Summary of Stakeholder Engagement

ACP-2023-083

Flylogix have submitted an airspace change request (ACP-2023-083) to establish this TDA. This document is a summary of the stakeholder engagement carried out by Flylogix in relation to this ACP.

Figure 2 - Map of TDA Proposal (segments bounded by separate colours)

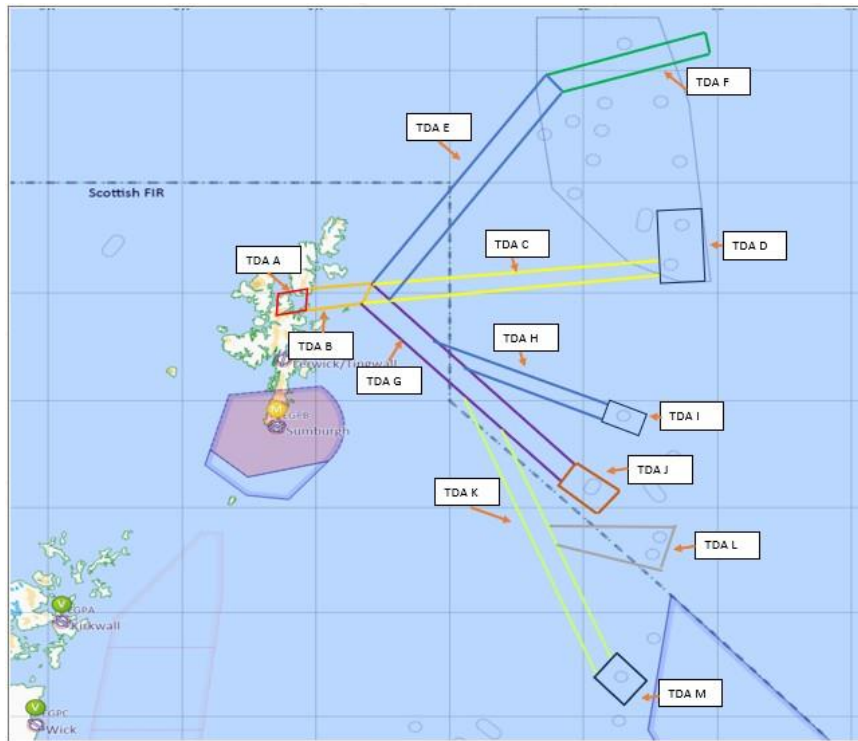
TDA 'F': Because this TDA crosses the Median Line and into airspace which is outside of both the UK FIR and airspace delegated to the UK, the planned use of a dedicated transponder code would need to be agreed with Norway and time may not permit that. Tina's suggestion is for the eastern edge of this TDA is aligned with the Median Line. As part of my procedure development, I understood from Ash Carnell that this TDA serves the Magnus platform, however when plotting it on the radar display this TDA lies south of the Magnus. In discussion with Avinor, I also understand there are no offshore installations within the TDA segment that lies east of the Median Line. As this small section of TDA looks like it will significantly complicate the procedures and approvals necessary to commence operations, can Flylogix reconsider the requirement for this TDA to extend east of the Median Line and is correctly aligned to reach the Magnus if that is the planned destination platform?

Of note, is the section of the TDA that crosses the Median Line into Norwegian managed airspace. For this, may we suggest that Flylogix coordinate the proposed TDA with Avinor as NATS Aberdeen will be unable to provide support for that section. From what I understand, Aberdeen ATC has already discussed this matter with you.

Good afternoon,
I had a closer look at the coordinates, and they are a little further north than I initially thought. This is a good thing because it means you will stay clear of the platforms within Tampen HTZ (see photo). However, there is an upcoming change to Tampen HTZ and in May/June it will increase in size and touch slightly into TDA F. Tampen will also at times have drone-activity so a coordination will be required.
We would like a phone call prior to the Flylogix drone entering Norwegian Airspace and another phone call when the drone is back in UK airspace. As for the rest of the TDA's they seem to be within UK airspace, but some are close to the Median line. As with previous Flylogix operations we do not need a phone call when those TDA's become active but should the drone for some reason stray outside the TDA we require a phone call as soon as possible.

NOTE: TDA F is no longer operationally required and after liaison with NATS Aberdeen and Flylogix has been removed from the ACP Submission and AIC.

- TDA F has been removed from the requirement.
- The proposed wording shall be included in the draft AIC
- Engagement had already started with Avinor but is no longer required as the operation will remain with UK Airspace.

TDA "F" can be removed from the ACP process as this is now not required. Hopefully this will help speed up the process.
